SERVICE BULLETIN

N° **139-774**

ATA 53 - REMOVABLE PANELS RETRO MOD INSTALLATION

This Service Bulletin provide the instructions on how to perform the removable panels retro mod P/N 3G5306P14711, which consists in the structural provision to allow the installation of the seat track P/N 3G5332A04351 on the rear panel assy.

Figure 1

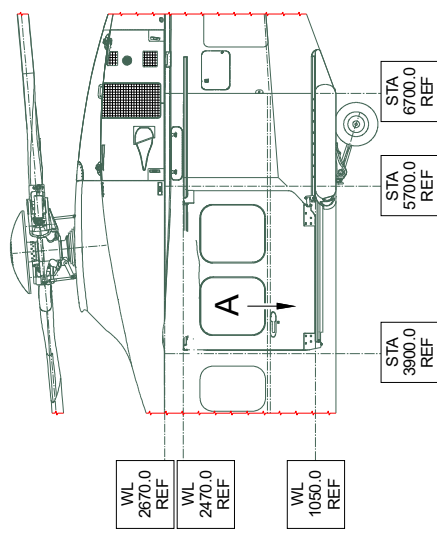
- 2.5 With reference to Figure 1 View A and Figure 2 Detail C, remove n°4 screws P/N MS27039-1-09 and n°4 washers P/N NAS1149A0316K from the rear panel assy and install n°4 screws P/N MS24694-S51 in the same position.

- 2.6 With reference to Figure 1 View A, drill n°4 holes $\varnothing 3.27 \div 3.35$ thru the structure and install n°4 rivets P/N NAS1097AD4-5A in the positions indicated.

- 2.7 With reference to Figure 1 View A and Figure 3 Section D-D, drill n°28 holes $\varnothing 6.45 \div 6.75$ thru the rear panel assy in accordance with the dimensions shown.

- 2.9 With reference to Figure 1 View A and Figure 3 Section D-D, install n°28 inserts P/N 999-5000-40-124 by means of adhesive EA 934NA AERO (C397).
 - 2.10 With reference to Figure 3 View E, install the plate P/N 3P5331A79151 on the structure in accordance with the dimensions shown by means of adhesive Hysol EA930NA (C231).

- 2.15 With reference to Figure 1 View A, Figure 2 Section B-B and Figure 3 Section D-D, install the seat track P/N 3G5332A04351 by means of n°28 screws P/N MS24694-S98 and n°2 screws P/N MS24694-S53.

Figure 2

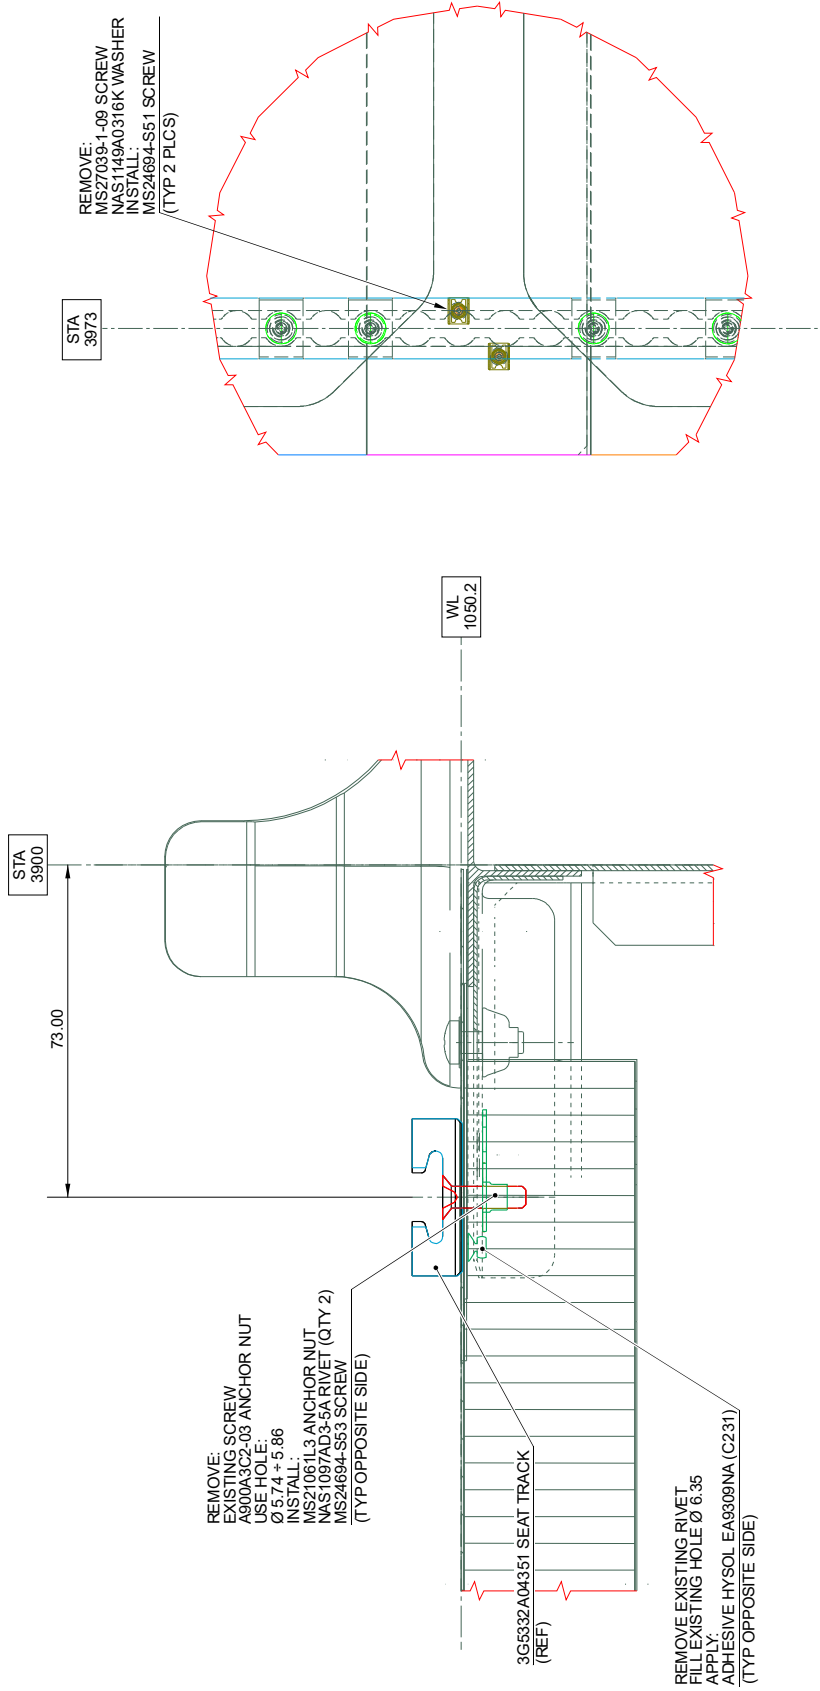
- 2.1 With reference to Figure 2 Section B-B, remove the existing screw and the anchor nut P/N A900A3C2-03 from the structure.
 - 2.2 With reference to Figure 2 Section B-B, install the anchor nut P/N MS21061L3 (use existing hole $\varnothing 5.74 \div 5.86$) on the structure in the same position by means of n°2 rivets P/N NAS1097AD3-5A.

- 2.3 With reference to Figure 2 Section B-B, remove the existing rivet from the structure in the position indicated and fill existing hole by means of adhesive Hysol EA9309NA (C231).

- 2.4 With reference to Figure 2 Section B-B, repeat steps from 2.1 to 2.3 on the opposite side.

Figure 3

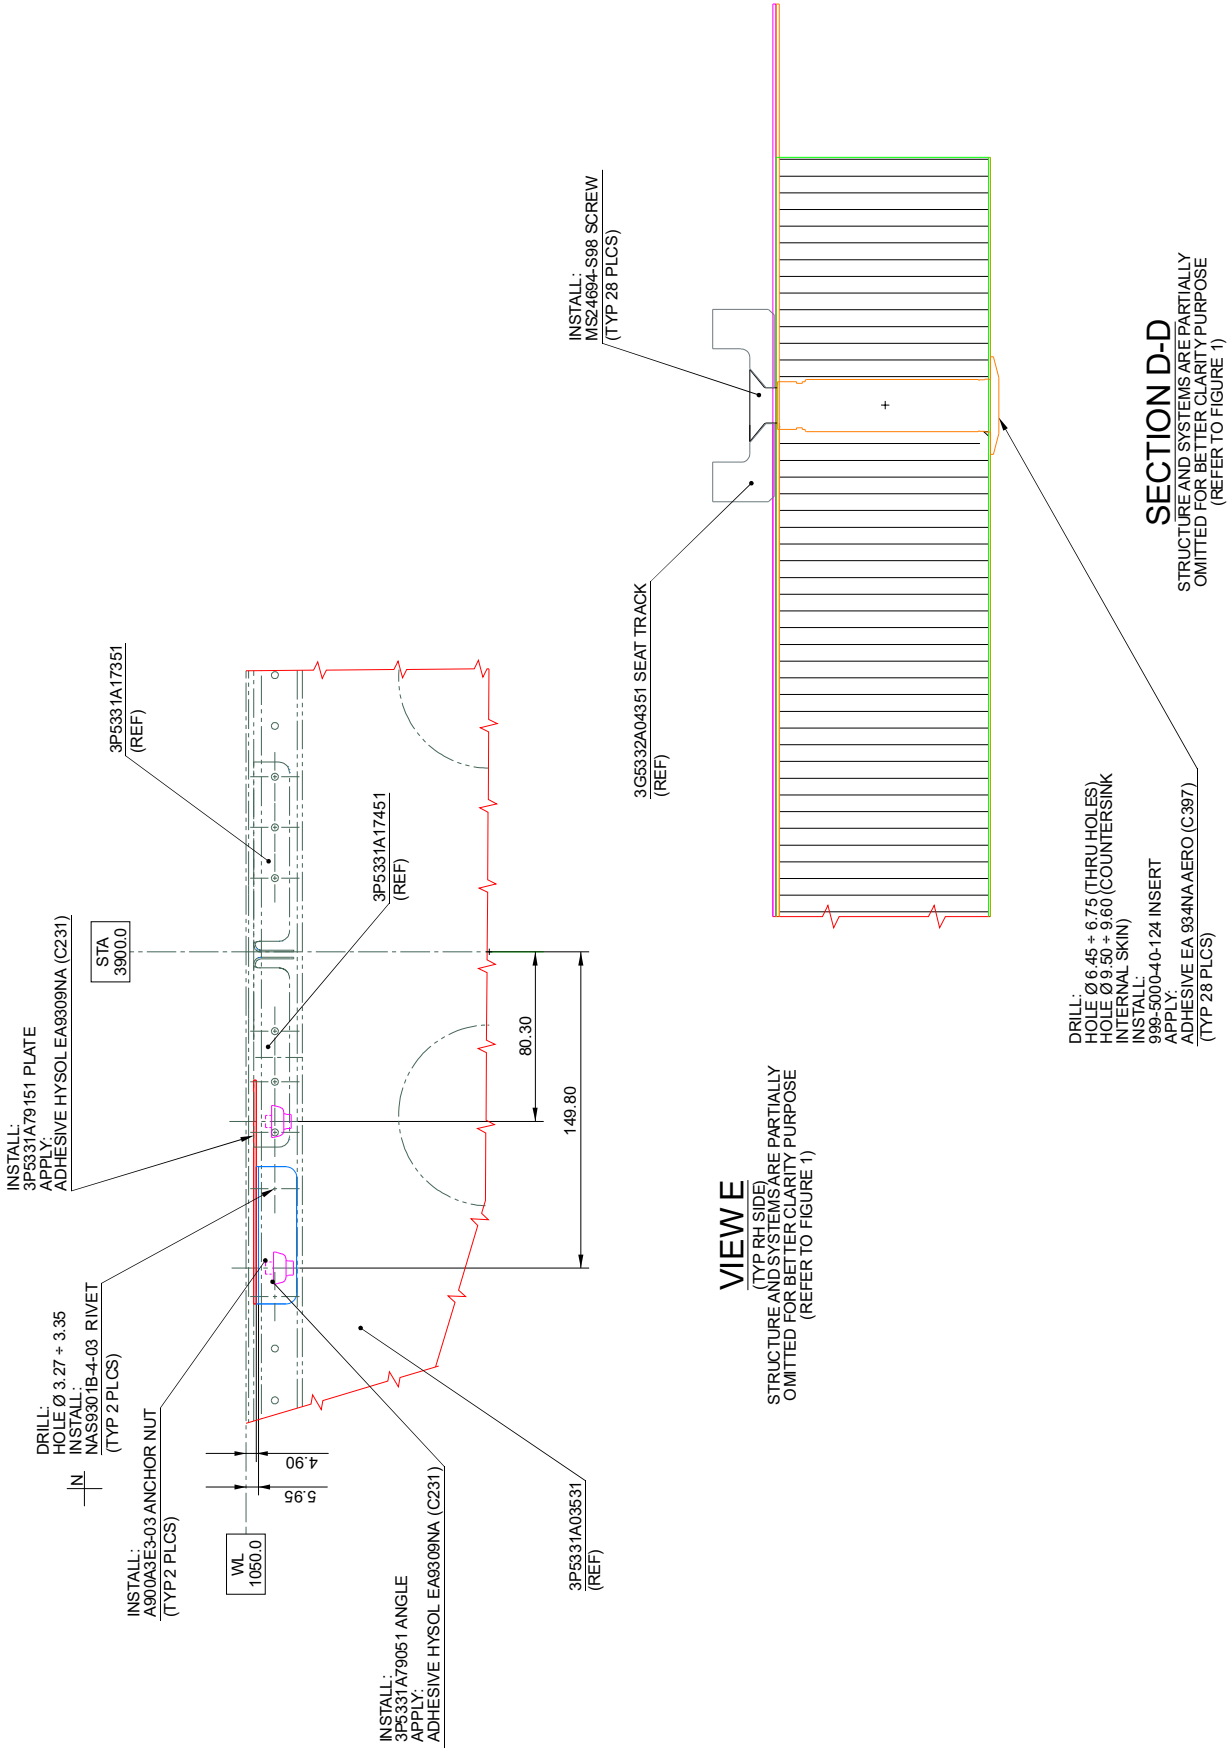
- 2.8 With reference to Figure 3 Section D-D, countersink the internal skin of the n°28 holes previously performed up to $\varnothing 9.50 \div 9.60$.

- 2.11 With reference to Figure 3 View E, drill n°2 holes $\varnothing 3.27 \div 3.35$ thru the structure using the existing positions.
 - 2.12 With reference to Figure 3 View E, install the angle P/N 3P5331A79051 on the structure by means of n°2 rivets P/N NAS9301B-4-03 and the adhesive Hysol EA9309NA (C231).

- 2.13 With reference to Figure 3 View E, install n°2 anchor nuts P/N A900A3E3-03 in the indicated positions.
 - 2.14 With reference to Figure 3 View E, repeat steps from 2.10 to 2.13 on the opposite side.
